**TOWN OF BAY HARBOR ISLANDS
DEVELOPMENT AND REVIEW COMMITTEE
AGENDA
October 14, 2021**

ITEM: Review and discussion of Site Plan Review Application by BH 103, LLC in order to construct a 35 unit Multi Family development to be located at 10270-90 East Bay Harbor Drive. Enclosed is a copy of the proposed site plans.

Subject: Site Development Plan Application – 2nd Revised Submittal
10270-90 East Bay Harbor Drive (35 DU)
Bay Harbor Islands Acct. No. SPR21-00013
MMPA Acct. No. 01-0702-1112

Site Development Plan Application – 2nd Submittal
10270-90 East Bay Harbor Drive Multifamily Residential Development (35 DU)
Development Review Committee – Comments on 9/20/21 Preliminary Revisions
September 23rd, 2021
Page 4

Date	09-07-2021	Sheet No.
Scale		A3.00
Project	2142

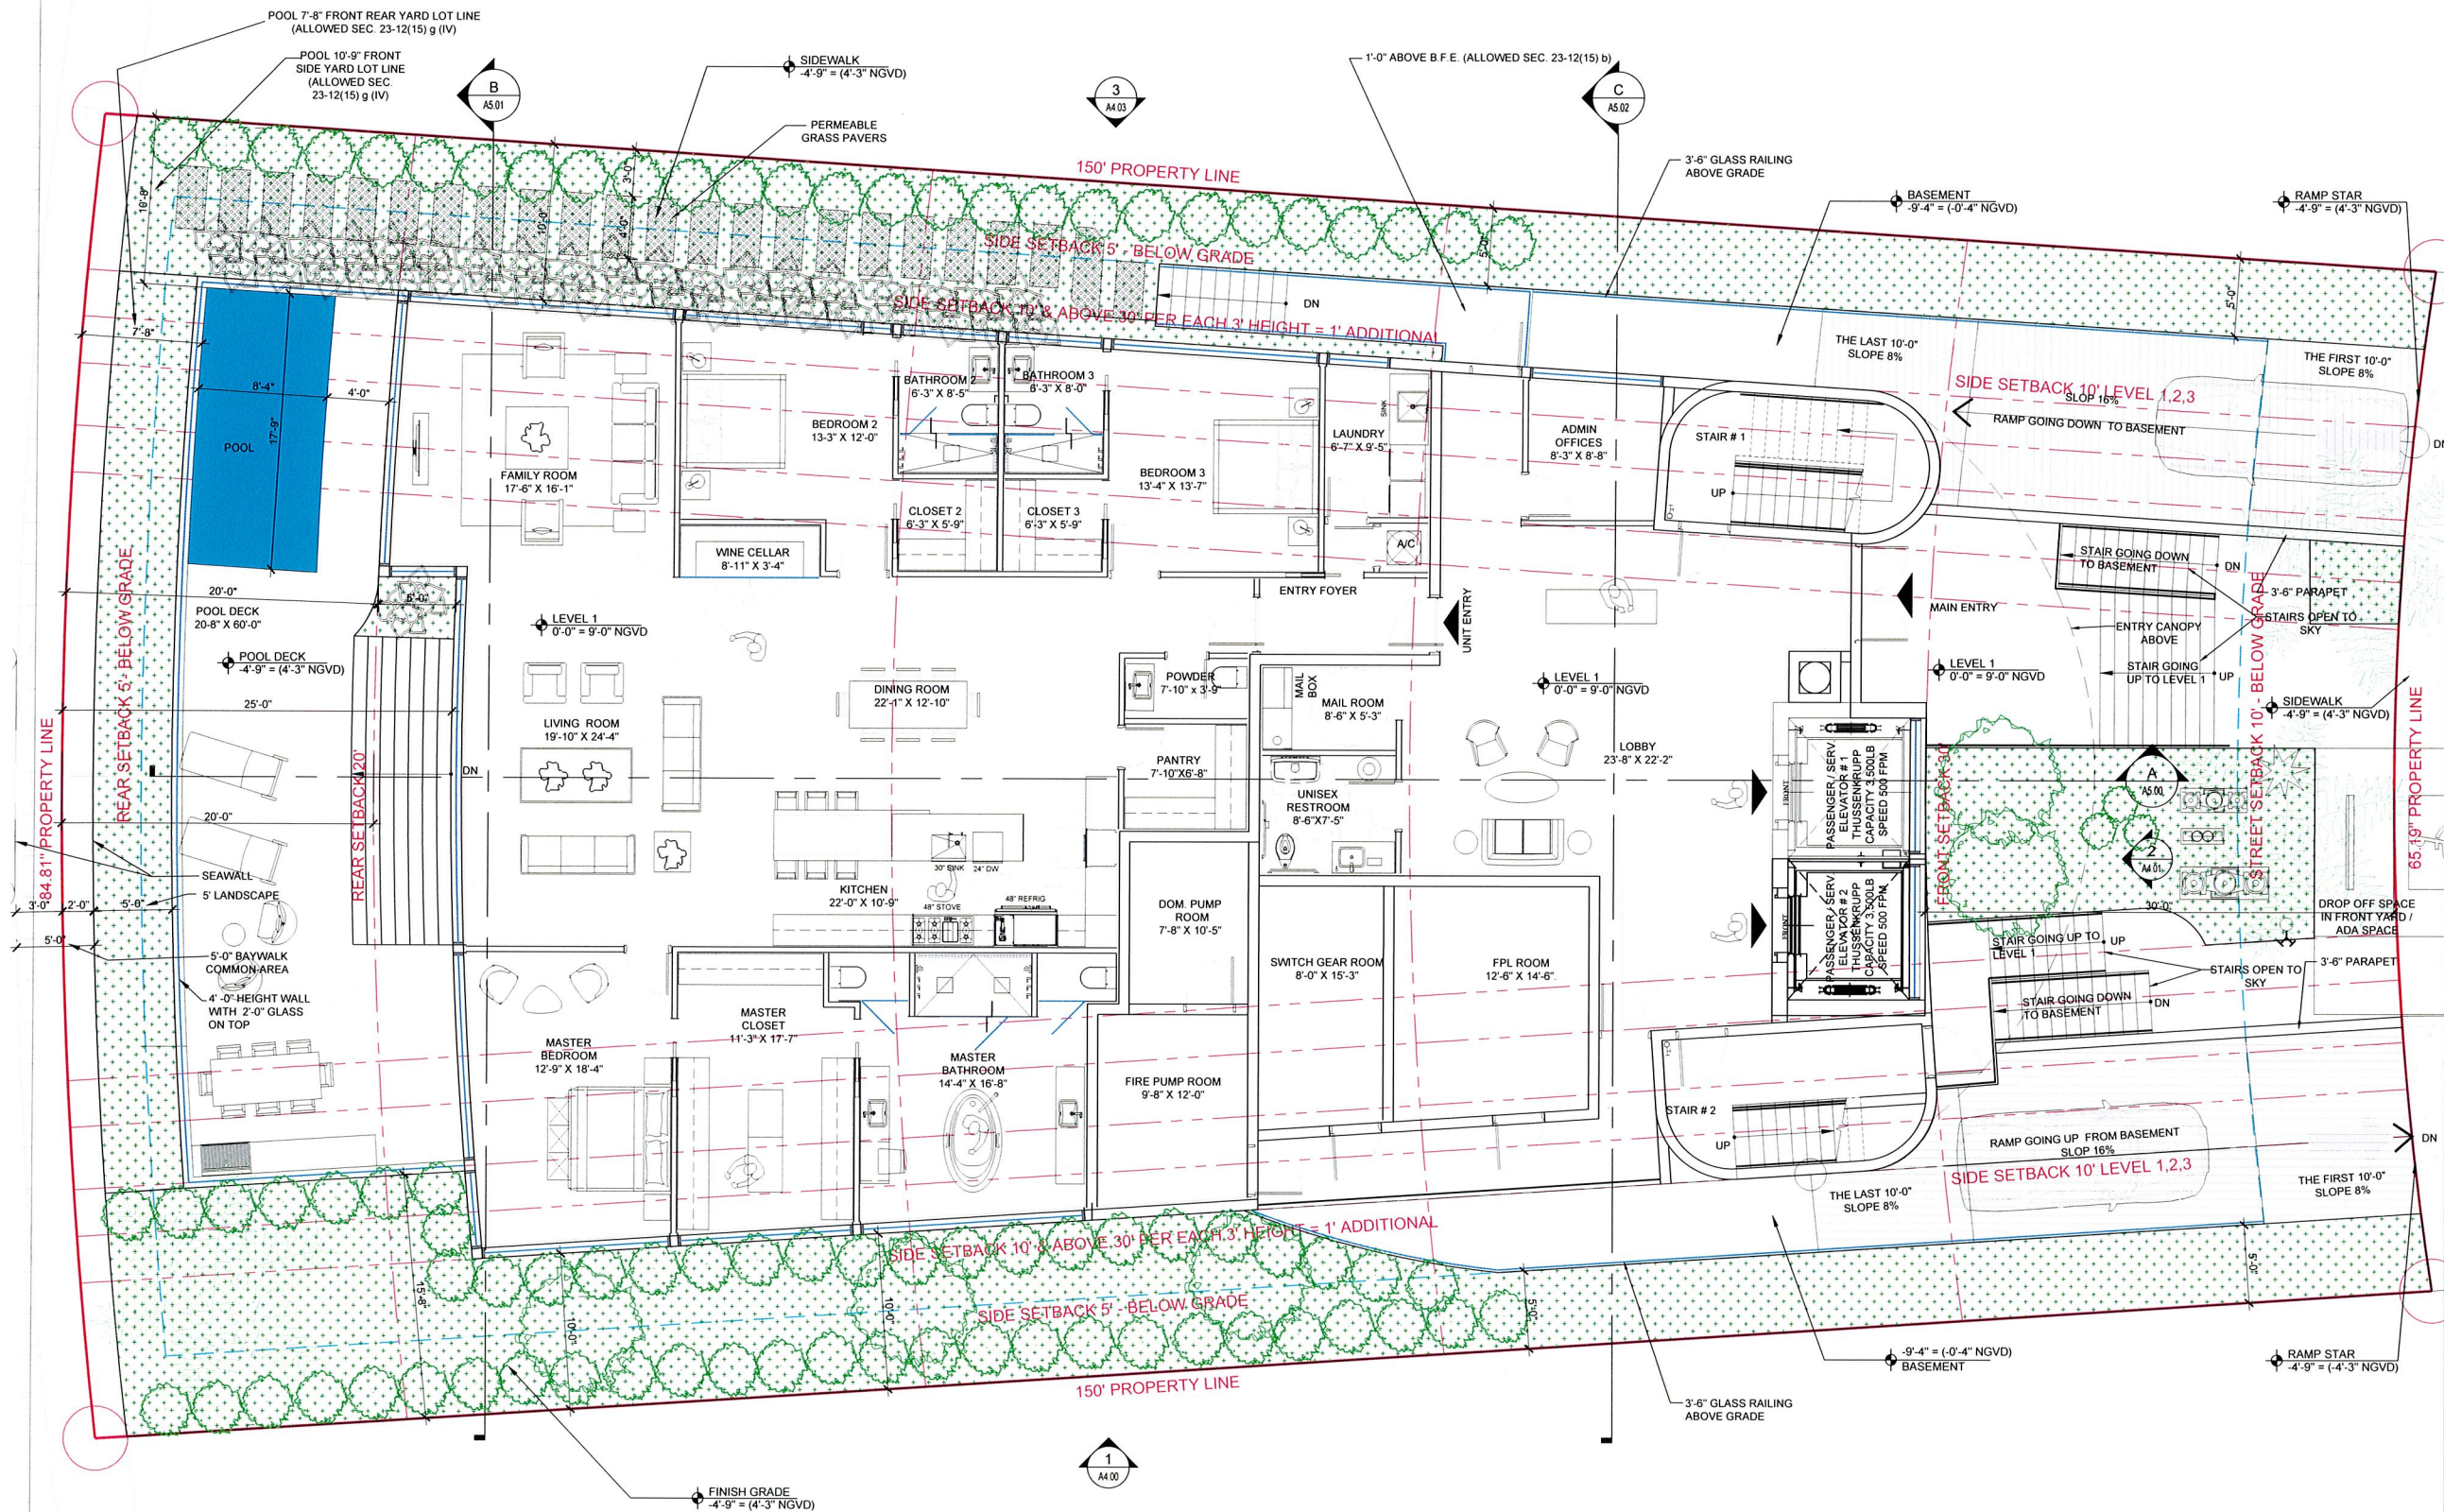
5. On Sheet A3.00 the Floor Plan Level "0" shows a proposed completely below grade / underground parking garage. Since 1993 FEMA has defined such structures as "basements" which are apparently not allowed under residential developments in designated flood zones - including FIRM Flood Zone AE-8.0 (see attached excerpt from FEMA Tech Bulletin 6-93). The Town Zoning Code still allows such structures, and some have been built in the Town several years ago (a few MFR / Hotels). The Town's former Bldg. Official was apparently not familiar with the FEMA rules and allowed a few underground garages. Those that were built had great difficulty dewatering the site / building below grade parking garages. Even with flood panels / pumps / other flood prevention features those sites all have flooding problems. Unless the current Bldg. Official allows this the proposed underground parking garage must be removed and the project redesigned with grade level (can be slightly depressed) / or an above grade parking garage.
